## Product Change Notice (PCN)

**PCN Number: PCN-65630262R-01**

Product(s) Affected: PDS1-M Series

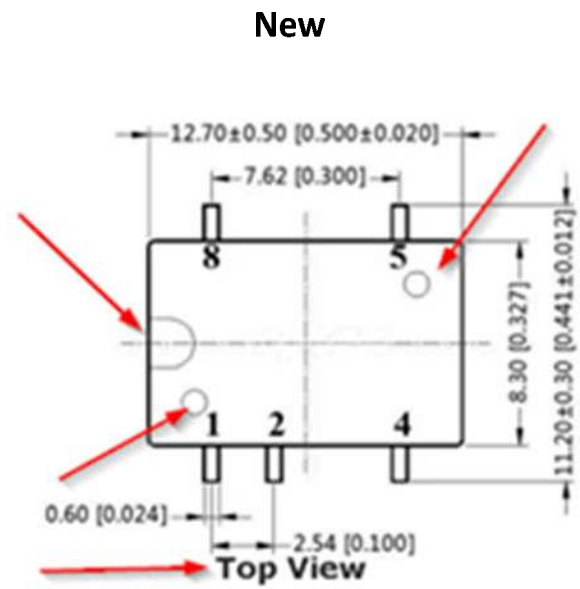
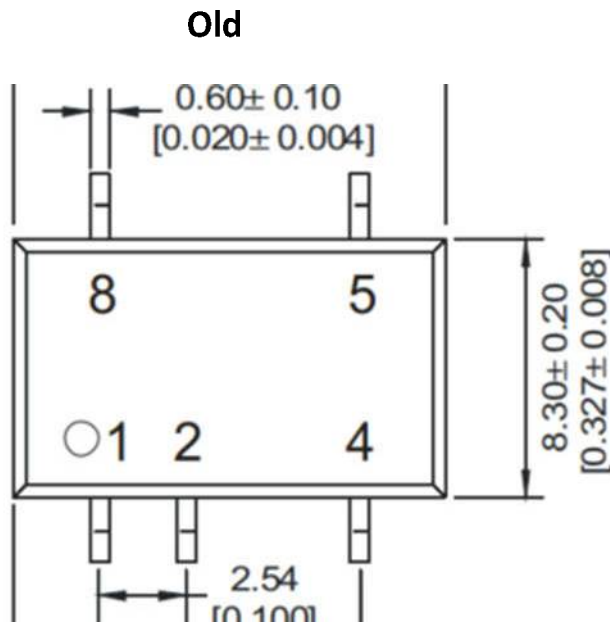
Reason(s) for Change: Mold update

Description of Change: Mold update causing minor housing changes from manufacturing contact points. See pictures below.

Additional Information: No change to form, fit or function
